**EA Amendment Assessment Report for the 12-month preconstruction  
bat monitoring study**

**- For the Great Karoo Wind Energy Facility situated in the Western  
Cape Province**

**March 2016**

**Reference no.: R-1603-22**

**Figure 6:** Location of GK11 within the sensitivity map of the amended Great Karoo Wind Farm turbine layout

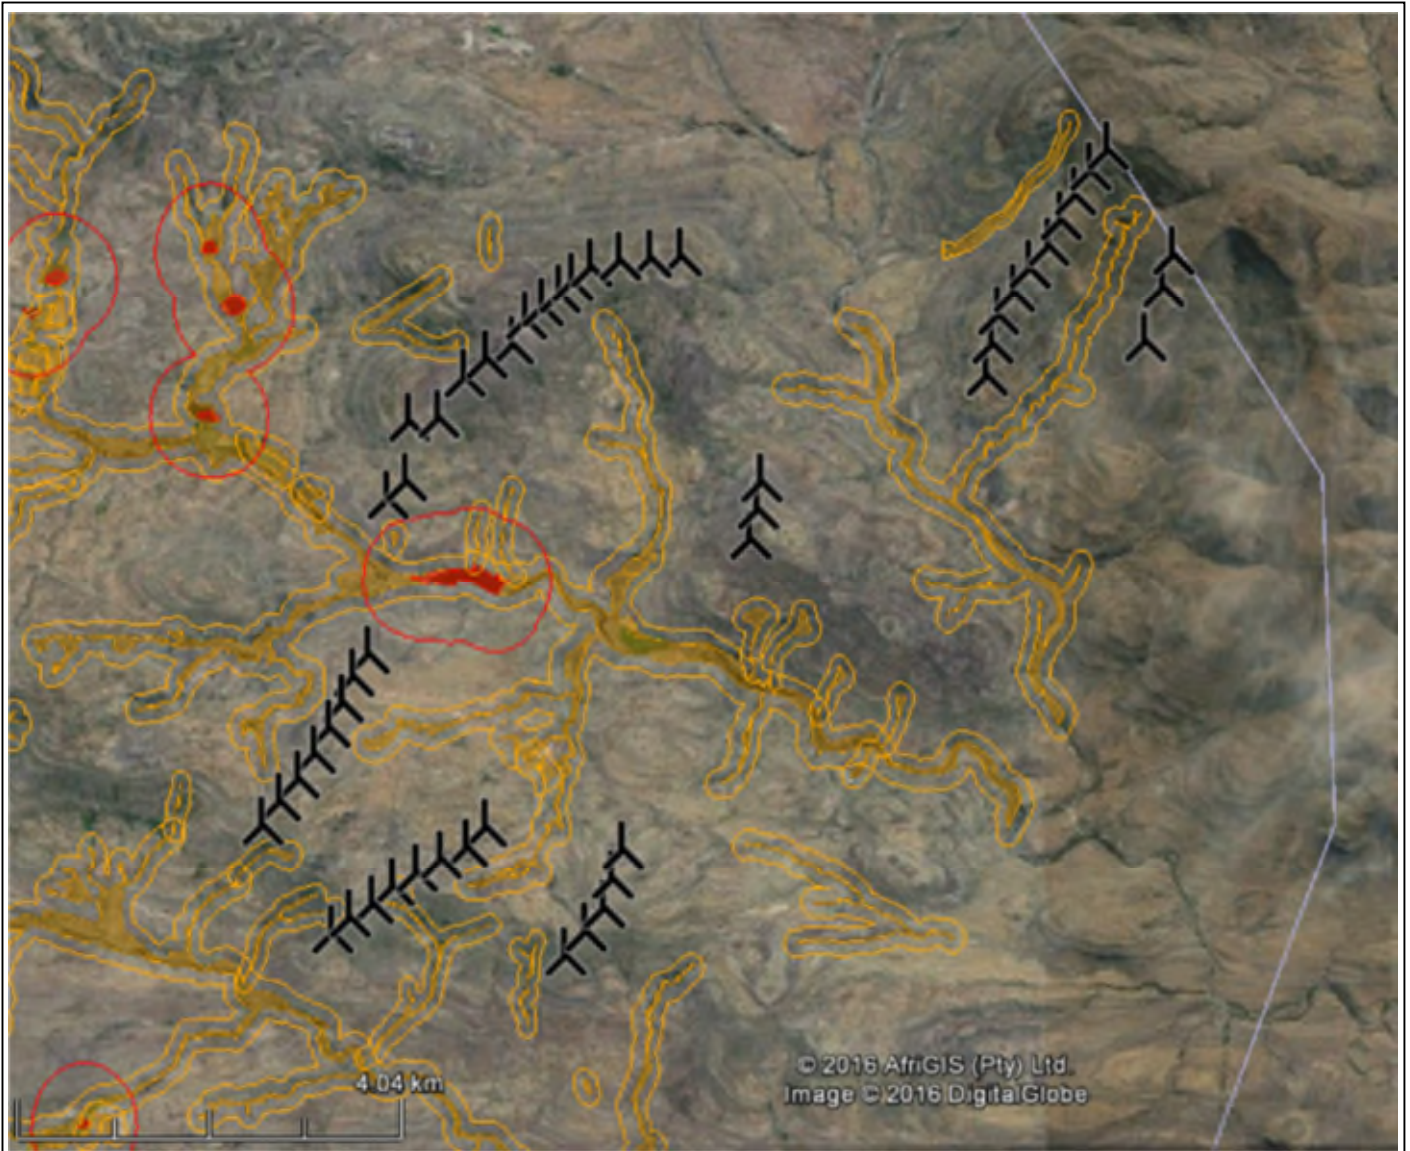
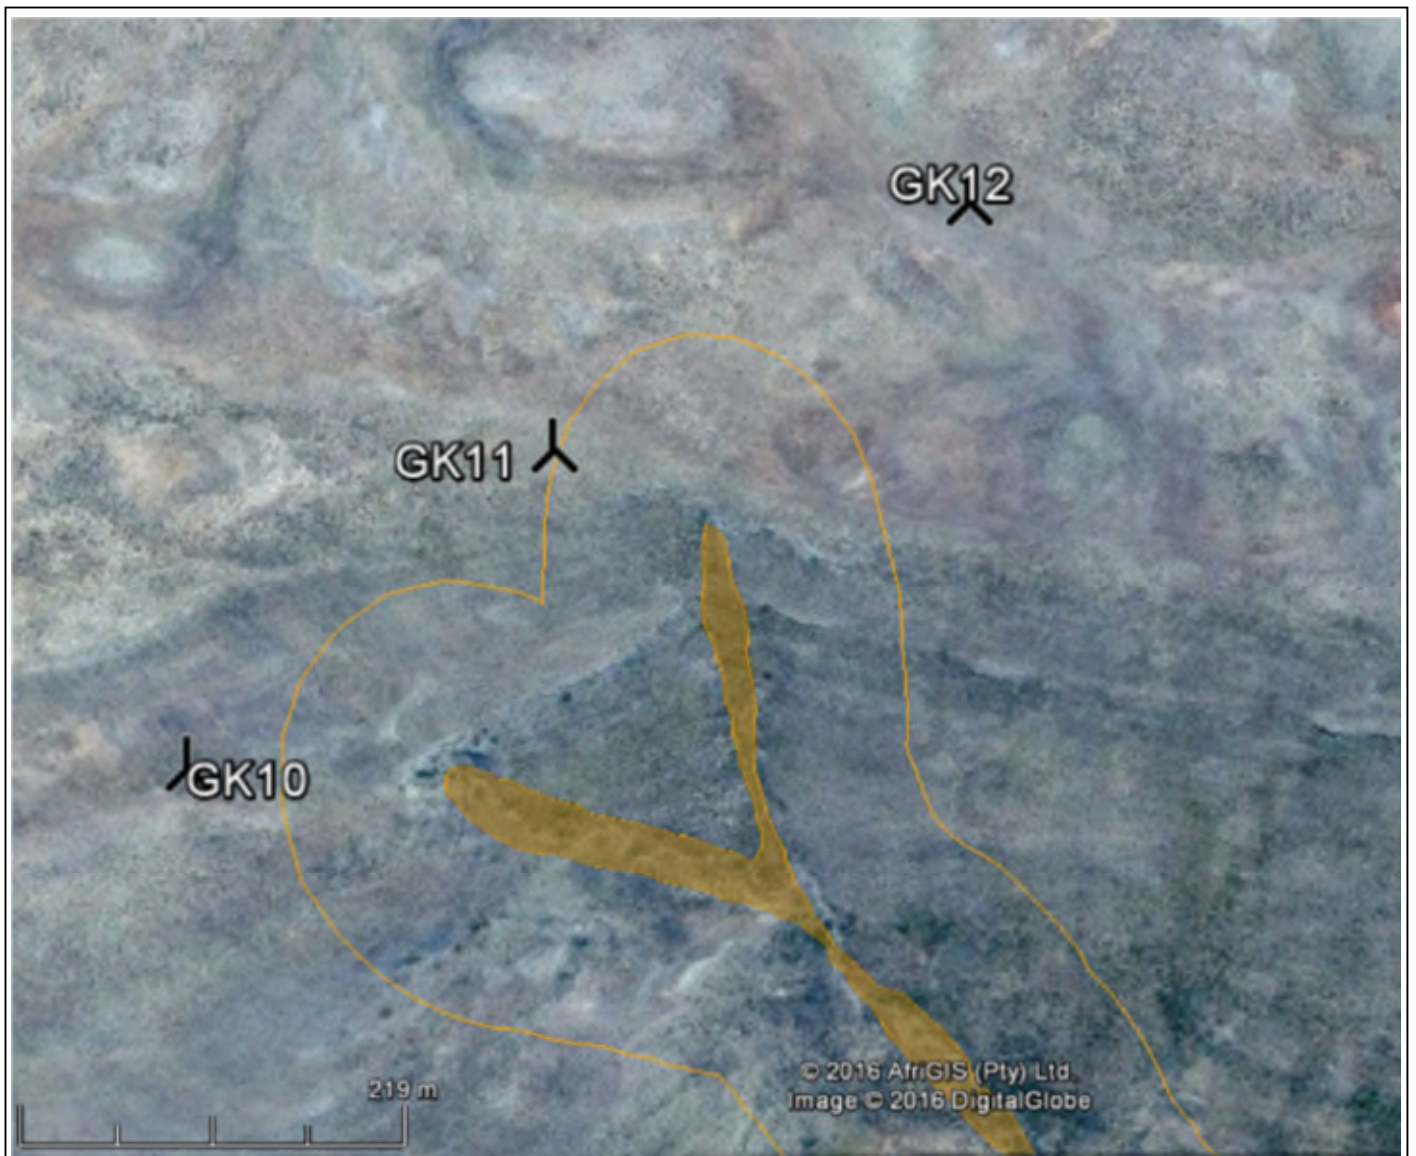
The amended layout of 52 turbines is respective of the Great Karoo WEF bat sensitivity map. No turbines are located within High or Moderate sensitivity areas and their respective buffer zones. Wind turbine GK11 is near to the boundary of a Moderate sensitivity buffer but is located out of the area (**Figure 6**).

There is no infringement of the amended layout on bat sensitive habitat thus, turbines do not need to be moved or removed from the layout.
